ST. LUCIE WEST COMMERCIAL ASSOCIATION, INC.

**RE: 1707 NW ST. LUCIE WEST BLVD. ST LUCIE WEST, FLORIDA
ULTA FAÇADE MODIFICATIONS**

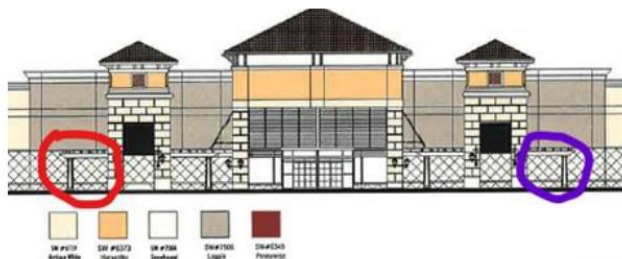
- **Pergola Removal:** Conditional Approval
Plans indicate the demolition of a section of the existing pergola (circled in red below). The committee feels that removing one side of the pergola feature that runs to the other side of the neighboring bay (Marshall's) without removing the other side (circled in purple below) would negatively affect the balance and symmetry of the area. Therefore, the committee requests that the section of the pergola feature circled in purple be removed.

Attn: Reviewers – in response to the comment received and included below – please see the updated plan submission set – with sheet D3.0 – added to remove the pergola section – that has been requested to remove.
